## **BRISTOL SUBDIVISION, FIRST ADDITION AND ADDITION**

APPLICATION NUMBER 21 DATE October 18, 2007

REQUEST Subdivision

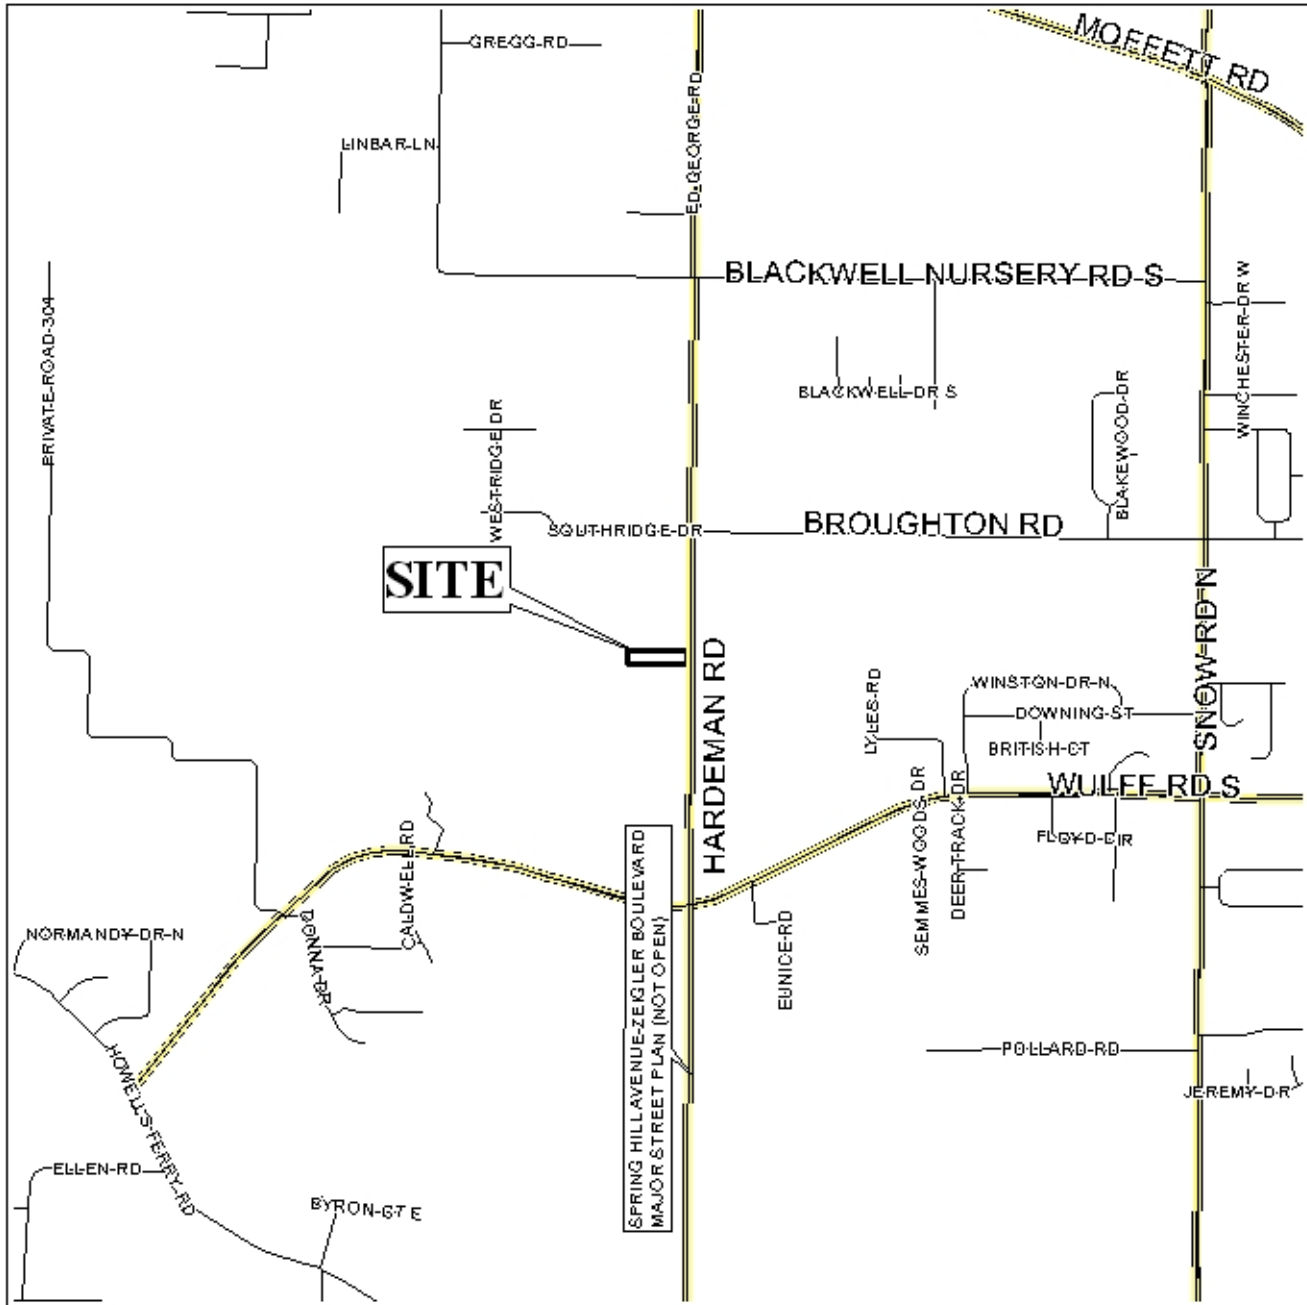
Lot 1 of Bristol Subdivision, First Addition was recorded in October 2002, and was created from a 20 acre parcel. The remainder of the parcel was designated as future development. The proposed subdivision will reduce the remaining area of the metes and bounds parcel to approximately 18 acres. It is recommended that the remaining area of the metes and bounds parcel be included in the subdivision and labeled as Lot 2.

The site fronts Hardeman Road, a planned major street, and the existing right-of-way is shown as 50 feet. The major street plan requires a 100 feet of right-of-way; therefore, the provision of a minimum 50 foot setback line (in addition to the minimum 25 foot building setback) from the centerline of Hardeman Road shall be required.

Since the site is located outside of the city limits, a note should place on the final plat stating that any lots developed commercially and adjoin residentially developed property must provide a buffer, in compliance with Section V.A.7. of the Subdivision Regulations.

Furthermore, compliance with the City of Mobile stormwater and flood control ordinances will be required. A letter from a licensed engineer certifying compliance with the City's stormwater and flood control ordinances should be submitted to the Mobile County Engineering Department and the Planning Section of Urban Development prior to the issuance of permits.

Based on the preceding, it is recommended that this application be held over to allow the applicant to submit:

- 1) Revision of the plat designating the remainder of the metes and bounds parcel as Lot 2.
- 2) Dedication of 50 feet from the centerline of Hardeman Road to allow 100 feet of right-of-way, in compliance with the major street plan.
- 3) Additional lot and notification fees and information.
